To: California Coastal Commissioners
From: Dr. Tim Barnett
Subject: New Appeal #A-6-LJS-07-114

Re: Wednesday, December 12, 2007 Agenda Item #20A
David and Bonnie Mehl's Home – Appeal #A-6-LJS-07-114

Figure 3 Erosion control (gunited cliff face) at
subject property (the one w/ pool)

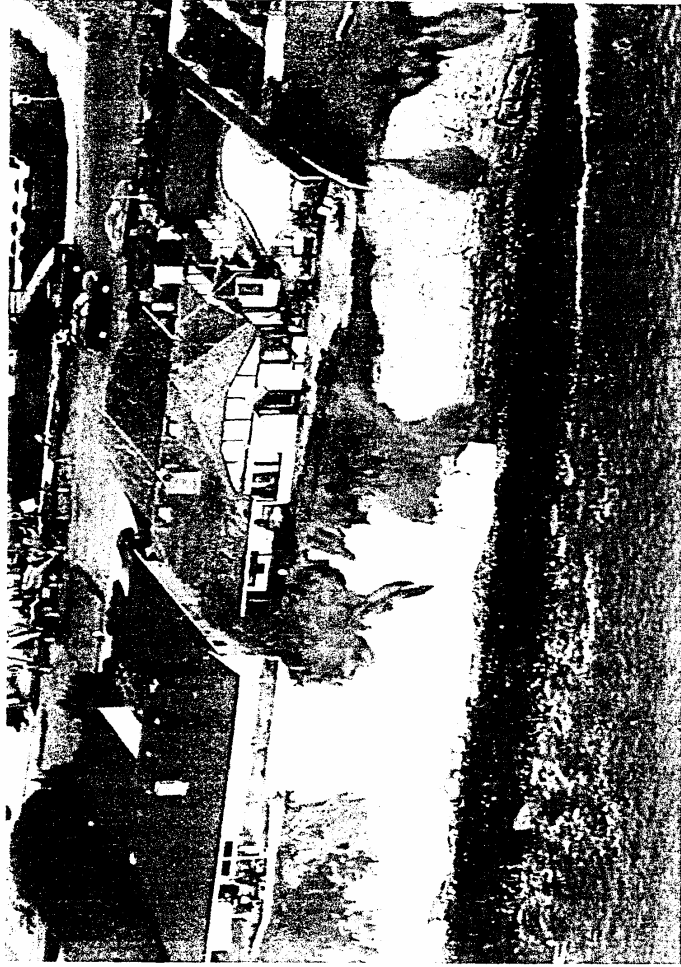
1. Aerial photos show the gunite covers fully one half of the available bluff at 5380 Calumet. This is not the 'only a small portion' phrase continually used by Mr. Peterson (attorney for Mr. Mehl) and colleagues. Check out the aerial photo in my 'Key Points' discussion.

In any event, what matters here is that the **intent** of the guniting/shore protection was to protect the subject lot from erosion. Why else would anyone apply an expensive procedure to the cliff area? They would not do it to be trendy and/or as an insurance policy. It clearly was done after severe erosion had started at the NW corner of the lot. That may be why they only gunited half of their cliff. Note aerial photos show fully one half of the bluff faced was gunited at one time; this is not the 'very minor portion' discussed in CWE. If it were placed as an 'insurance policy' against erosion they would have treated the entire cliff.

Figure 9 Bluff edge at subject residence. Notice vertical character of the cliff. The northern corner of subject house is just out of sight, but only about 6-8 feet from bluff top (note space heater for scale). Taken from house just to north.

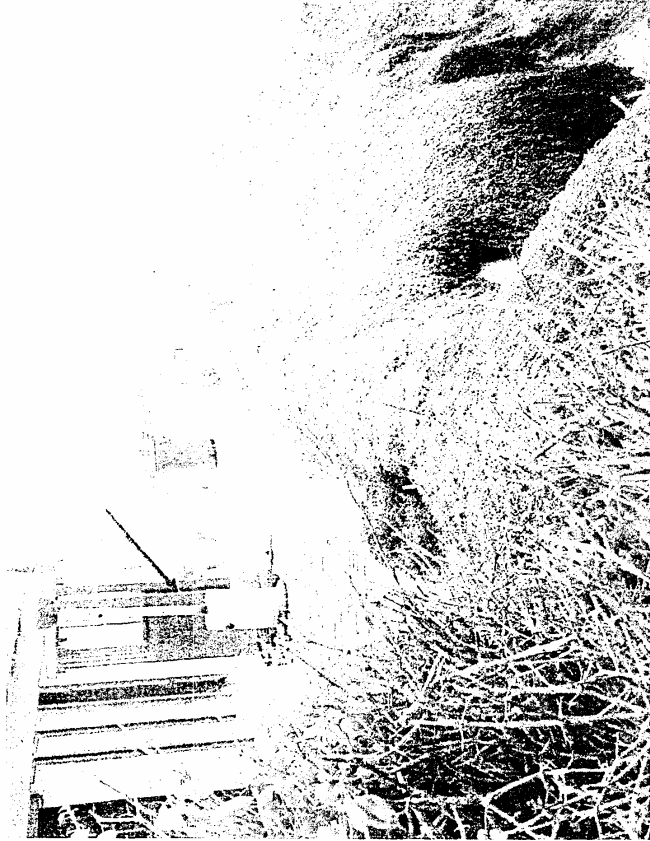
The face of the bluff cliffs at the site is very nearly vertical, indicating an active erosion situation. There is also a wave undercut section of bluff, which WCE assert does not exist. I have pictures of it and would advise they have a walk on the beach to verify this themselves. By the way, they need to take account of the undercut in their estimates of bluff edge location, a fact they do not mention. Their estimate of bluff edge position near the southern edge of the lot is most likely incorrect, unless they have done this.

1. You indicated to me Wednesday that the City apparently required no demolition plan for removal of the existing house and foundations from the subject property. *Yet the existing house and foundation, which are to be removed, come within only few feet of the coastal bluff edge.....they are in the sensitive coastal bluff zone* (see Figure 9 of my 1 August memo to you on problems with this property).

Figure 9 Bluff edge at subject residence. Notice vertical character of the cliff. The northern corner of subject house is just out of sight, but only about 6-8 feet from bluff top (note space heater for scale). Taken from house just to north.

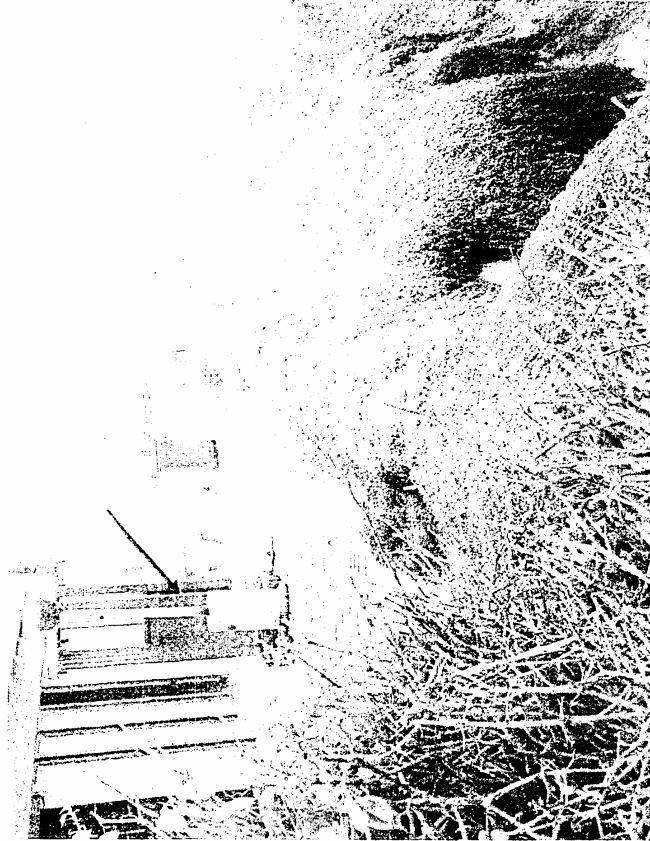
1. You indicated to me Wednesday that the City apparently required no demolition plan for removal of the existing house and foundations from the subject property. *Yet the existing house and foundation, which are to be removed, come within only few feet of the coastal bluff edge.....they are in the sensitive coastal bluff zone (see Figure 9 of my 1 August memo to you on problems with this property).*
